UNITED STATES ENVIRONMENTAL PROTECTION AGENCY

Re: December 2020 Operable Unit Two Remedial Action Work Plan
Ringwood Mines/Landfill Site, Ringwood, New Jersey

USEPA AND NJDEP COMMENTS ON THE DECEMBER 2020
OPERABLE UNIT TWO REMEDIAL ACTION WORK PLAN FOR THE
RINGWOOD MINES/LANDFILL SUPERFUND SITE

Figure 4: Sample Air Monitoring Locations (RAWP Attachment B)

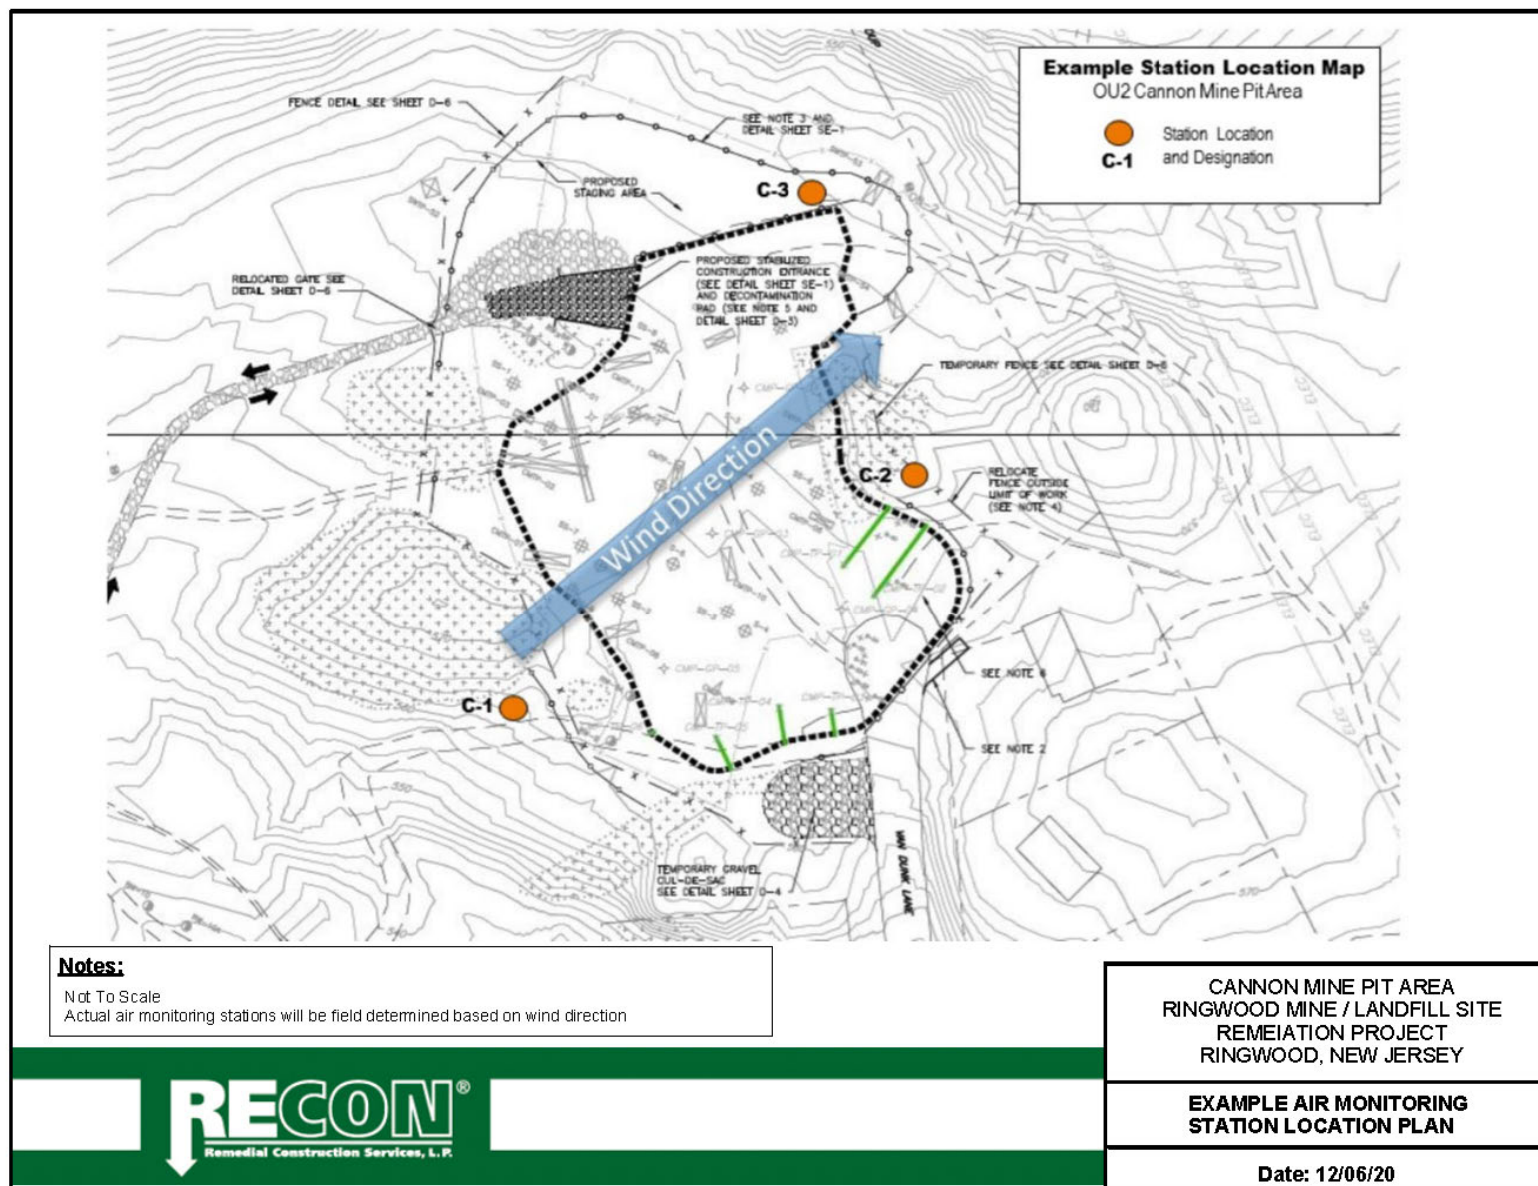
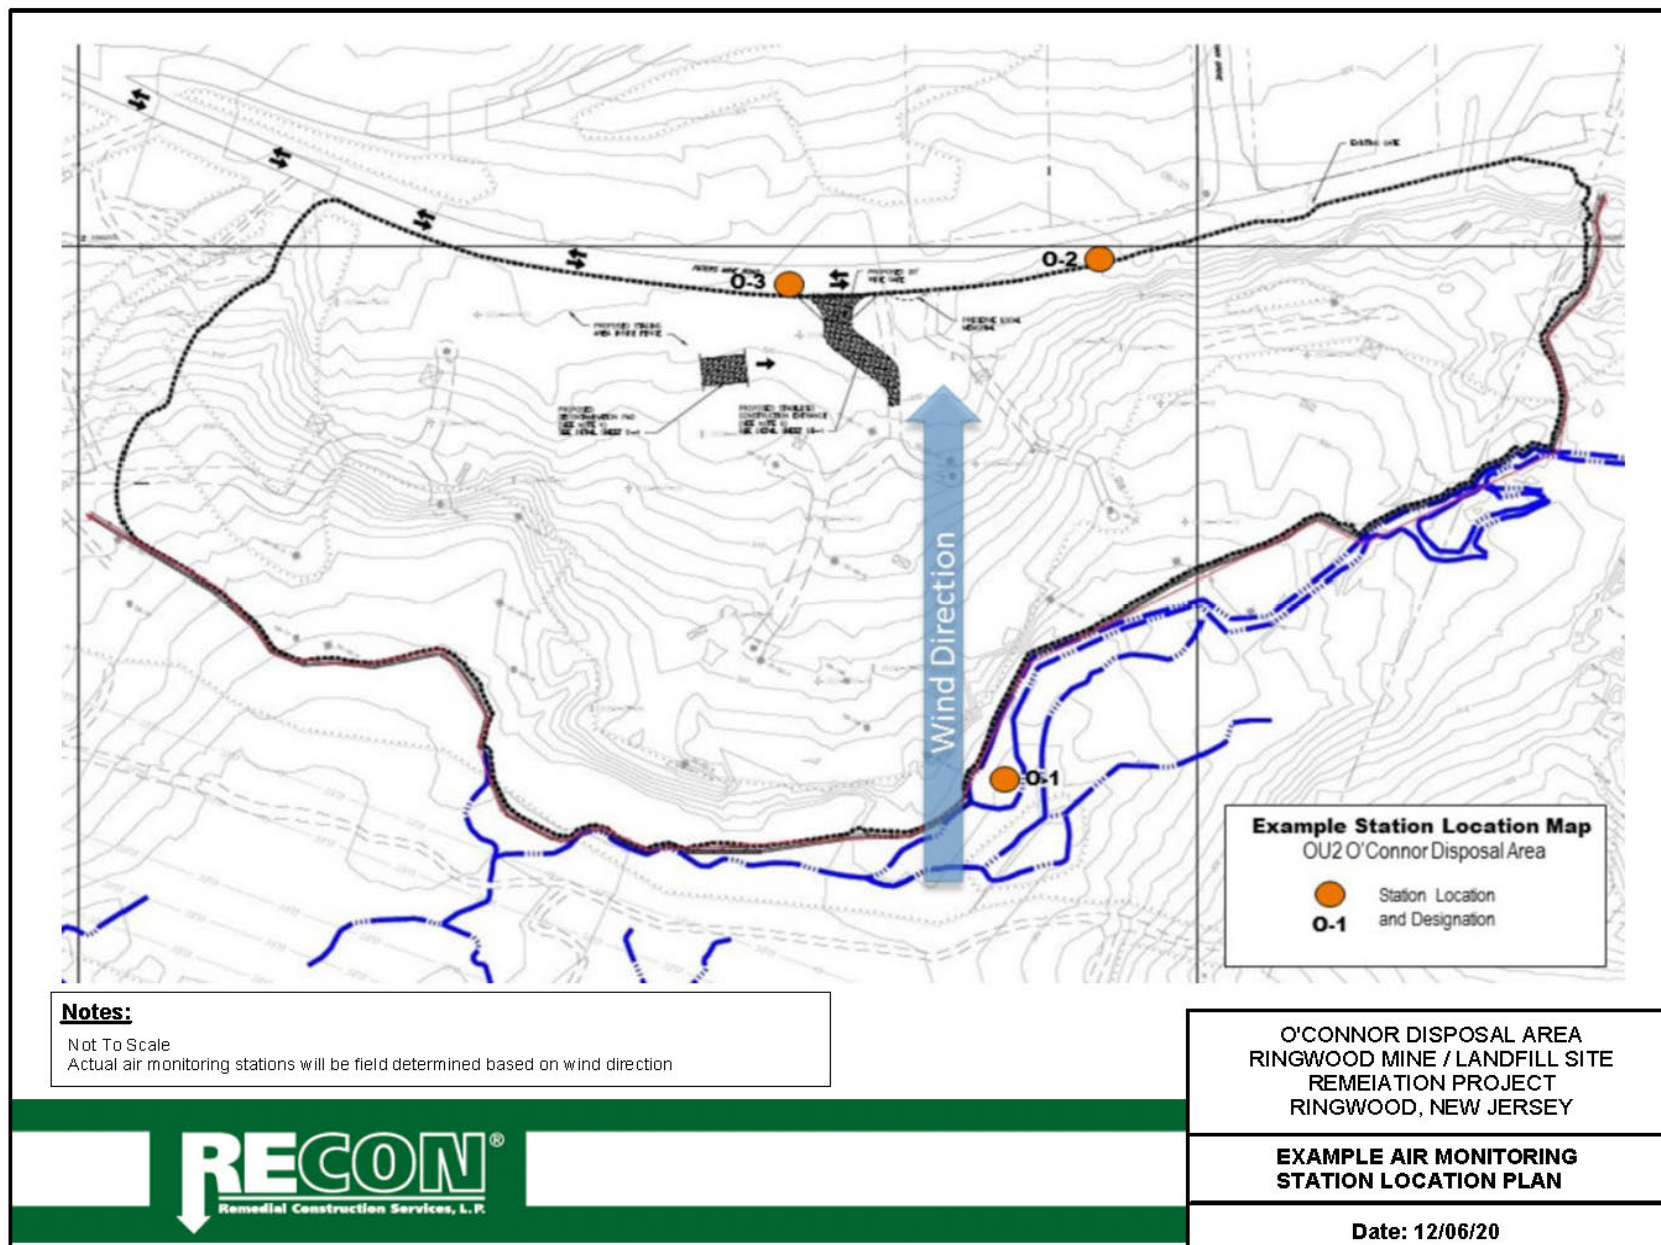
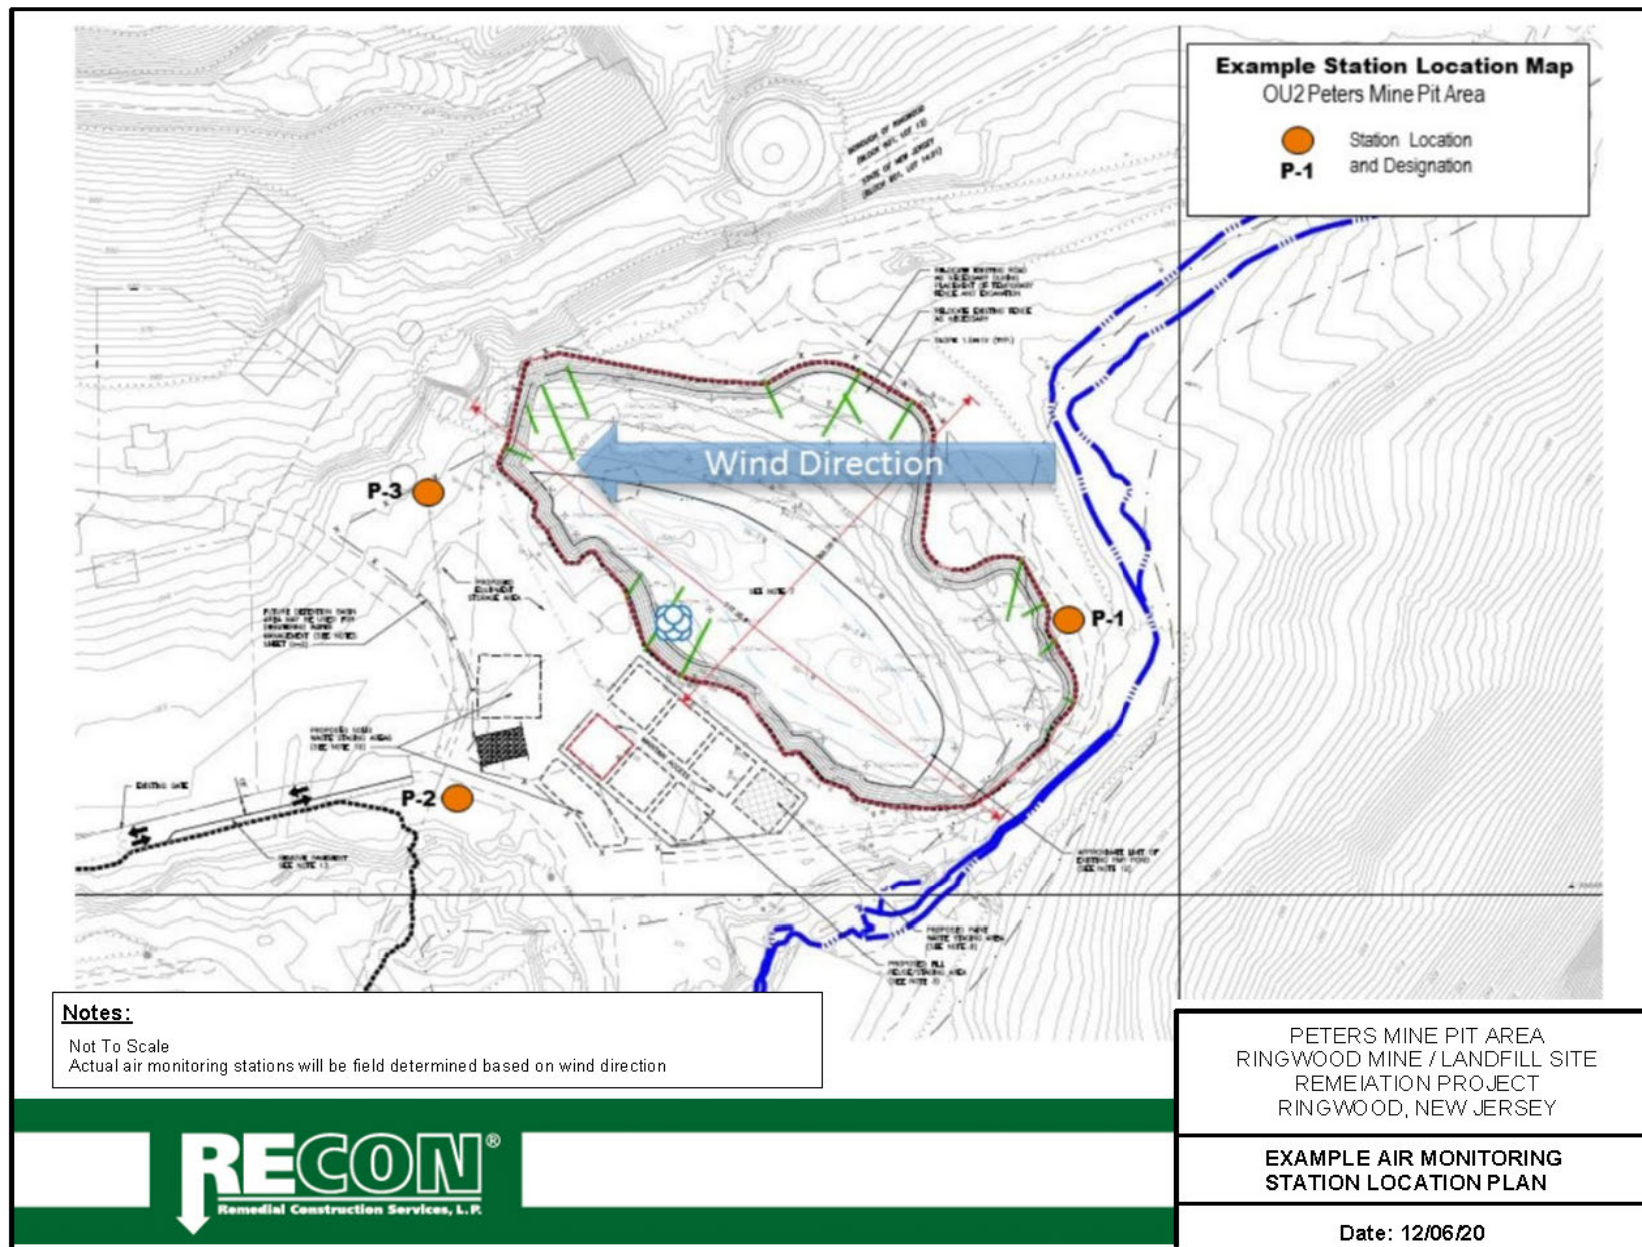
daily, based on the location of work and wind direction. *Community members may want to review the sample air monitoring station location maps (shown in Figure 4 at the end of this fact sheet) to make sure they are comfortable with this arrangement. They may also want to request communications about the actual placement locations of the stations during cleanup activities, including the distance the air monitors are located from the actual work. If community members know of sensitive populations or locations that should be monitored more closely, this information could help inform monitor placement.*

- c. Have dust mitigation equipment and staff available to be used, if necessary, on a 24 hour/7 days per week basis.
- d. Show locations of nearby residences on the Monitoring Station Location Plans, sheets 232,233. And 234. Show locations of NAAQS monitoring stations on these drawings.
